Attachment 4 – Q & A - Response to Matters Raised at Preliminary Briefing

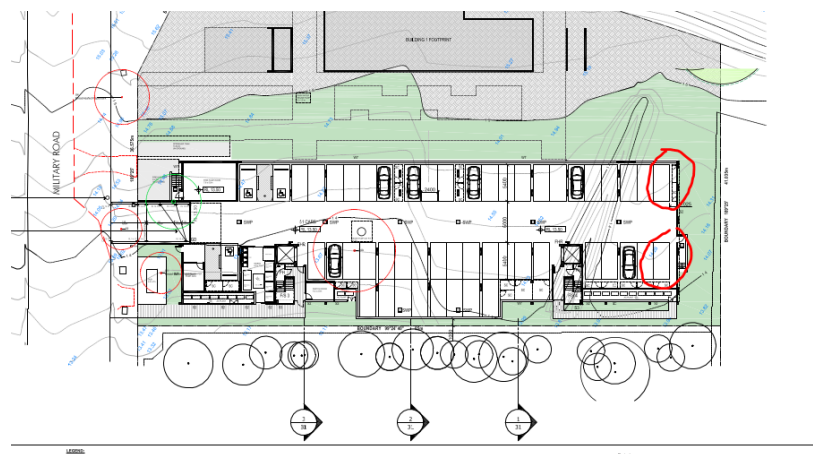
2. The workability of tandem (front to back) parking spaces is potentially problematic where suitable arrangements to ensure no conflict between unit holders occurs.

Suitable conditions are nominated requiring all tandem (front to back) spaces within the car park for both spaces to be allocated to a single 2 and/or 3 bedroom unit to ensure no conflict/issues arise.

Tandem parking spaces will be allocated to the larger units / town house typologies to ensure there will be no issues with access.

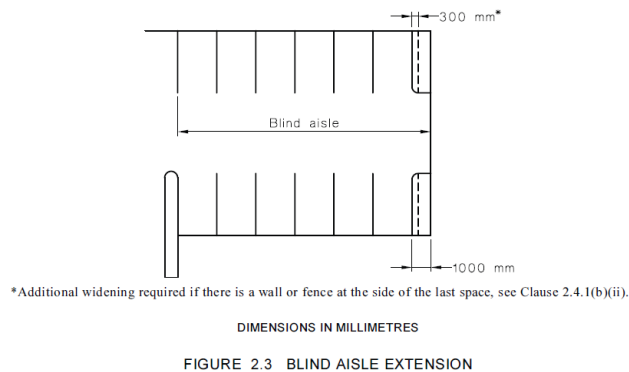
3. Have the end carparking spaces been checked as compliant with the required standards.

The plans show that the parking aisle is extended 1025mm past the last parking bay which complies with the requirements of AS2890 Figure 2.3

Traffic engineers have confirmed compliance with the end of aisle treatment requirements. Please refer to Bitzios Consulting's Traffic Impact Statement.

Figure 1: TUFLOW Results Showing 1% AEP Flood Depths (Stormwater Diversion Report)

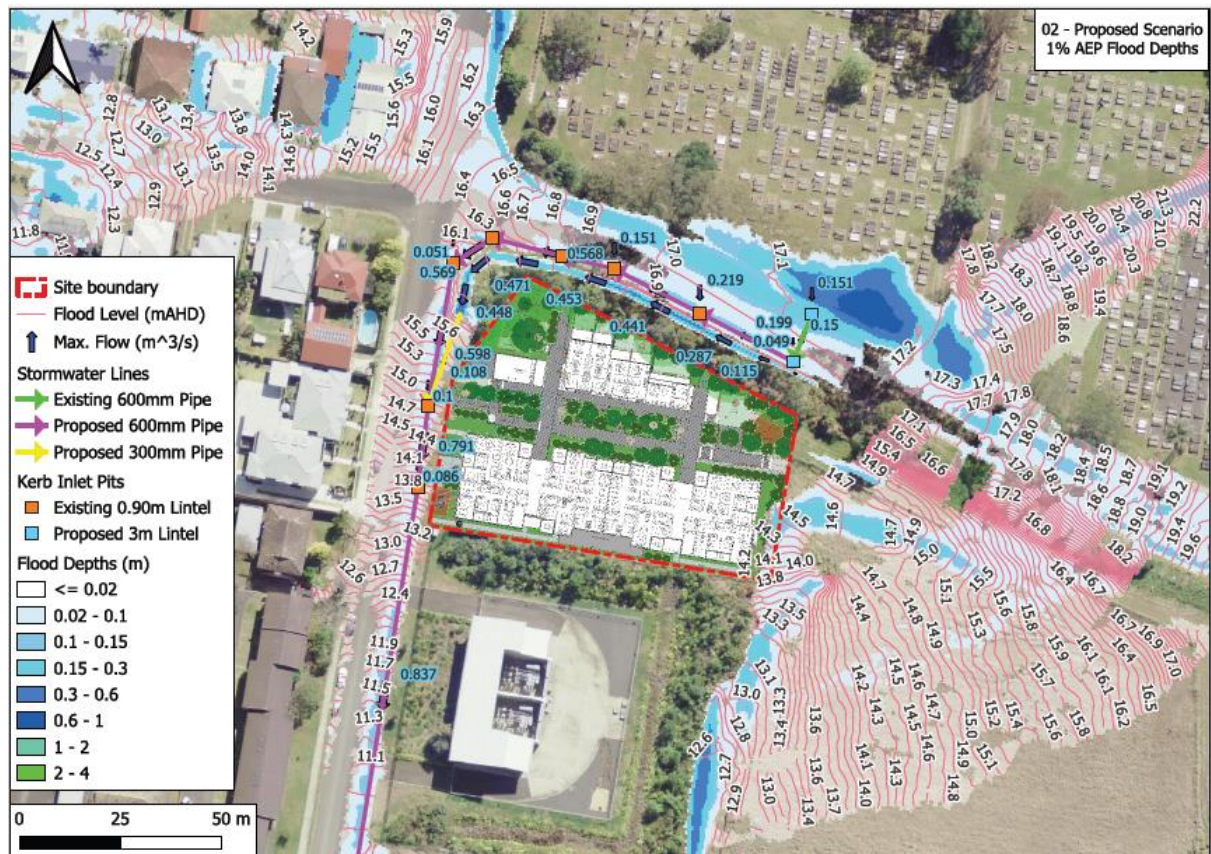
5. Have the flows of stormwater in the event swales overtop been considered. What event are the stormwater swales modelled for and has analysis been undertaken as to where flows likely to present/occur in a more extreme event.

The TUFLOW modelling presented in the stormwater diversion report confirms that the proposed stormwater system, including the swale, is designed to accommodate extreme stormwater events, up to and including the 1% AEP rainfall event, as illustrated in Figure 1 below.

The swale has been modelled to Council's required design parameters and storm events, with results provided in ADP Consulting Engineer's Stormwater Diversion Report. The modelling demonstrated that no overland flows will be entering the development. Further analysis was carried out to investigate the 200 year and 500 year. The stormwater flows are maintained within the swales in the 200 and 500 year events. The introduction of new kerb inlet pits on Crawford and Military Road, further mitigate the overland stormwater levels. It is to be noted that the building and basement levels are designed to be above the PMF levels to ensure no overland flow enters the site and flows are fully diverted into the upgraded pit and pipe system.
